DSOX2022A-03

S E R V I C E N O T E

DSOX2022A – Oscilloscope, Mixed Signal, 2 Channel,
200MHz

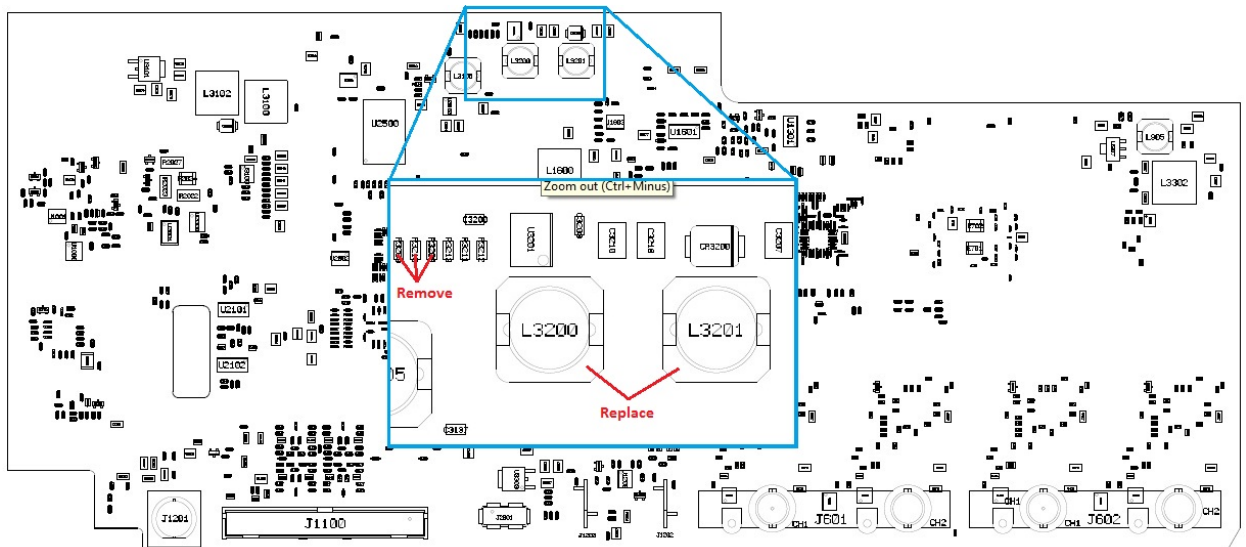
With the oscilloscope power turned on and while under normal operation, the unit emits a hissing noise.

2. As the picture indicates, remove the three resistors (0699-7209, 1 Ohm) located at R3208, R3209, and R3210. They are not to be replaced.
3. Remove as well the two inductors (9140-6474, 100uH) located at L3200 and L3201 and replace them with inductors with part number 9140-6151 (68 uH).
4. Re-assemble to the point where the unit could be powered up to verify that the hissing is indeed gone. If the hissing is not gone, please, check modifications.
5. When the hissing is gone, put oscilloscope back together.
